CHEVROLET—CENTRAL OFFICE

TECHNICAL SERVICE BULLETIN

SUBJECT: HOT WEATHER IDLE - 1961-62 CORVAIR
AND CORVAIR "95"

BULLETIN NO. DR #546

FIGURE 1

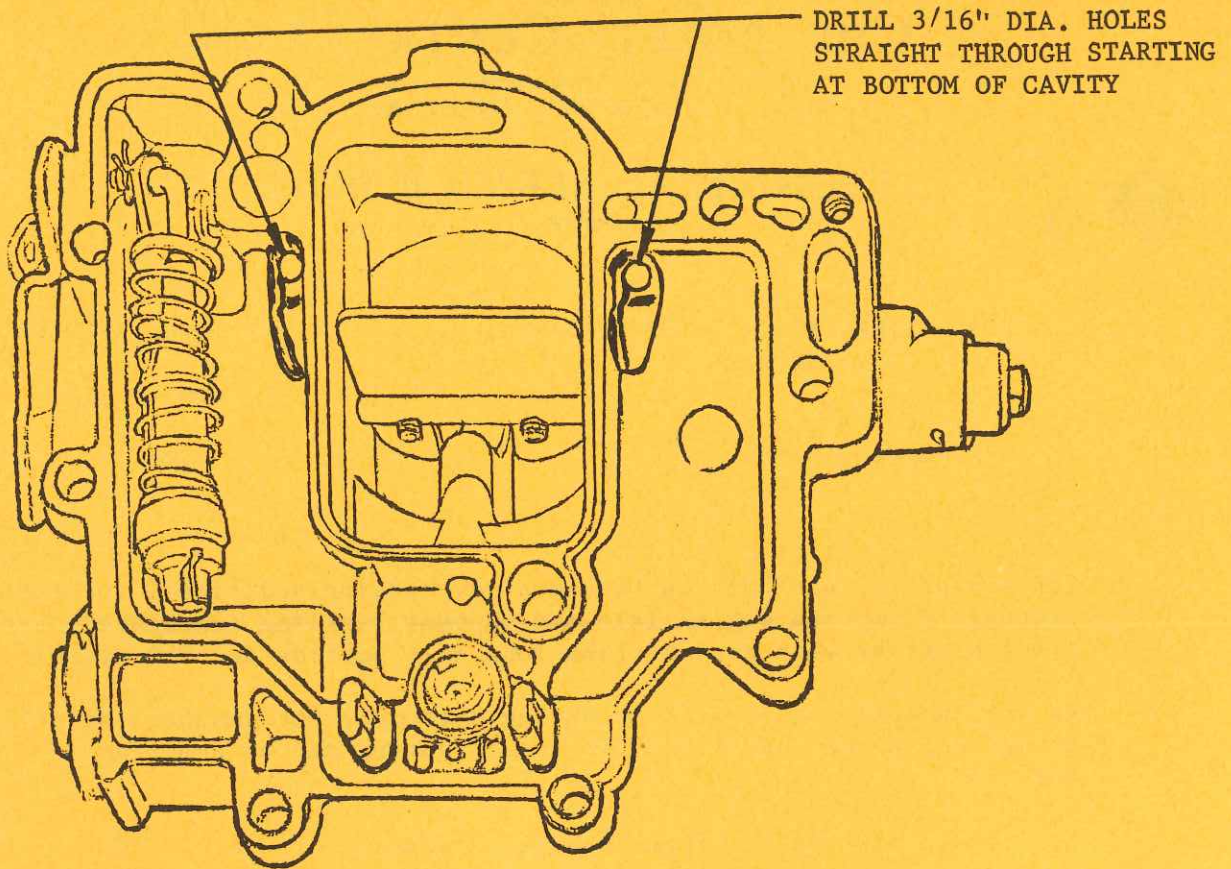
1. Remove bowl covers from both carburetors.
2. Invert bowl covers and remove float, float needle and bowl cover gaskets.
3. Drill two (2) 3/16" diameter holes in each bowl cover located as shown in Figure 1 on the reverse side. Holes must be drilled straight through to break out inside the air horn as shown in Figure 2.
4. Clean out all chips, remove burrs and reassemble the carburetors.
